Our Case Number: ABP-318802-24

Re: Proposed development of a resource recovery centre (including waste-to-energy facility)
in Ringaskiddy, County Cork.

Observation on SID application – case reference PA04.318802, Ringaskiddy, Co Cork.

Proposed development of a waste incinerator by Indaver NV, t/a Indaver Ireland.

Composite map of Indaver site showing that the incinerator would be almost entirely built on land zoned for education (RY-I-09).
by Catriona Gannon-Reid

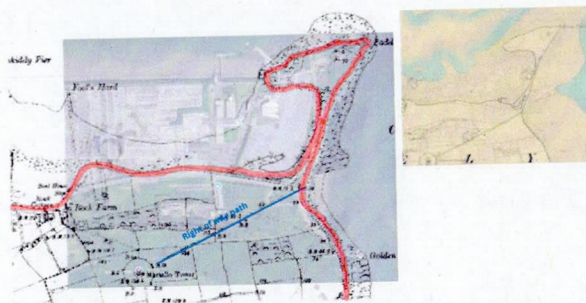
Firstly, although the proposed incinerator site does indeed cross over between two different zones (RY-I-09 and RY-I-15), the actual *incinerator* is built almost entirely on RY-I-09, which is

zoned for educational use. The remainder of Indaver's land, zoned RY-I-15, is left undisturbed. However, In Indaver's Planning Report (pg. 8), it states that: "the site is predominantly zoned RY-I-15 and **part** zoned RY-I-09" [emphasis added]. This leads the reader to believe that only a **small** portion of land zoned for educational use (RY-I-09) will be occupied by the incinerator, when in fact the incinerator will be built almost **entirely** on this land. Additionally, the incinerator would make it more difficult for the rest of site RY-I-09 to be used for its intended educational purpose, as not only would the location of the incinerator make access to the site challenging but the plume and dioxin deposition would make it an unattractive place to build an educational facility.

For illustrative purposes I have created a deck of composite photos where I have layered an image of the site as proposed by Indaver over an image from the County Development Plan to show the exact placement of the incinerator in relation to sites RY-I-09 and RY-I-15:

Figure 1: Screenshot taken from EPA, 2023. *Ireland's Climate Change Assessment. Volume 1: Climate Science – Ireland in a changing world. Summar for Policy Makers.*

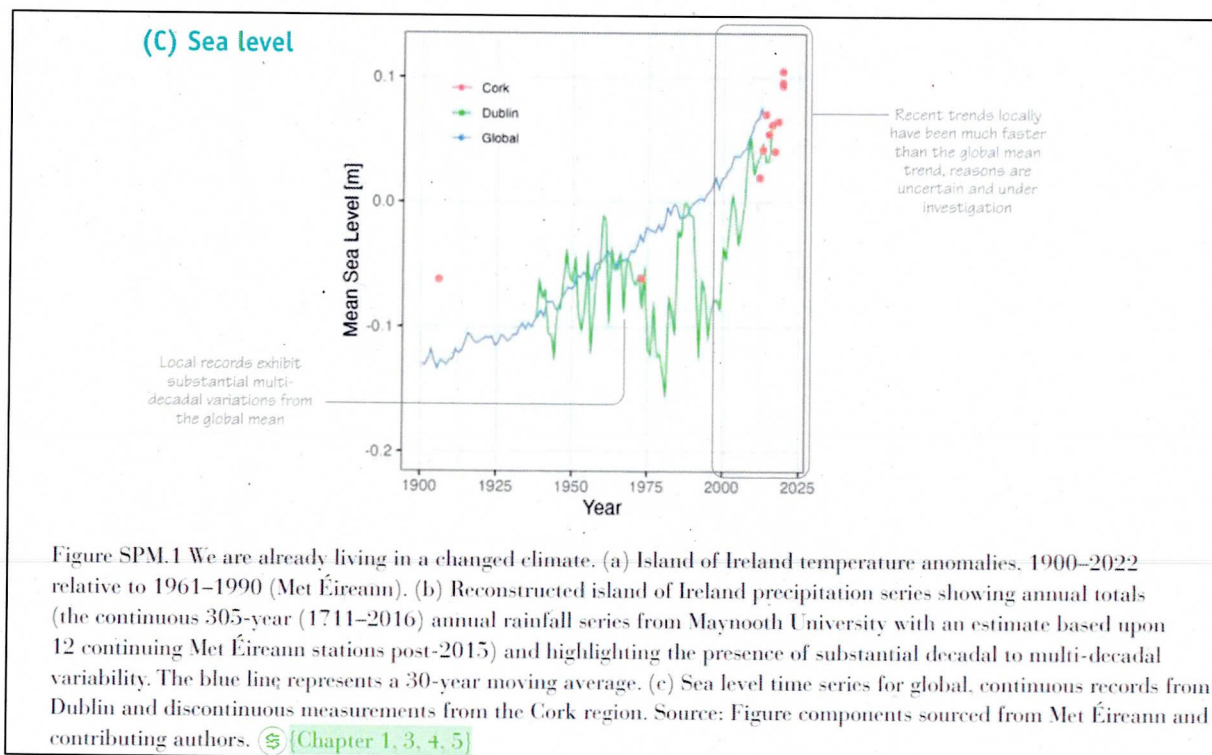
In the documents where the property extent of the OSI PLACE map from 2001 is used to denote both the High Water Mark and the edge of Indavers property. This map is incorrect based on literature about sea level rise and work done in Cork. According to documents published by the EPA, sea level rise has massively accelerated in recent years, especially since 2000. In Figure 1, is it clear to see that the records from Cork with data sourced from Met Eireann the average sea level in 2025 is notably higher than it was in 2000.

This means using any imagery or claims about the sea level from 2001 is a gross mishandling of geographic information and shows little to no due diligence done to assess if the claim about the foreshore was accurate or not. This claim to the high water mark is significant because it is the underpinning to the coastal protection plan proposed by applicant Indaver. They claim that the coastal protection plan in the form of sacrificial shingle will be entirely placed above the foreshore. The foreshore is defined as “the bed and shore, below the line of high water of ordinary or medium tides, of the sea and of every tidal river and tidal estuary and of every channel, creek, and bay of the sea or of any such river or estuary;” (Sourced from the Foreshore Act 1933).

Figure 3: Screenshot from Appendix 13.3 from the EIS submitted by applicant Indaver.

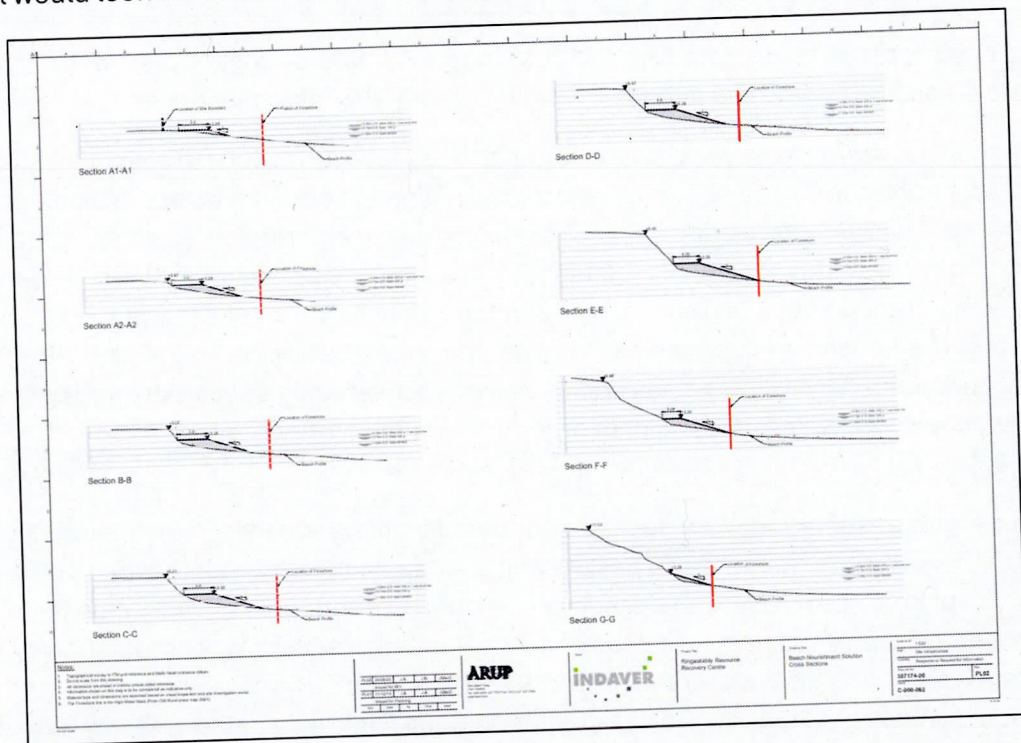
All these maps in Figure 3 I would say, based on my beach walks are misleading and do not truly represent where the foreshore line is, and should be ignored totally. In all the above, the foreshore denoted by Indaver with a red line, is actually in the middle of each of the cross sections at a minimum.
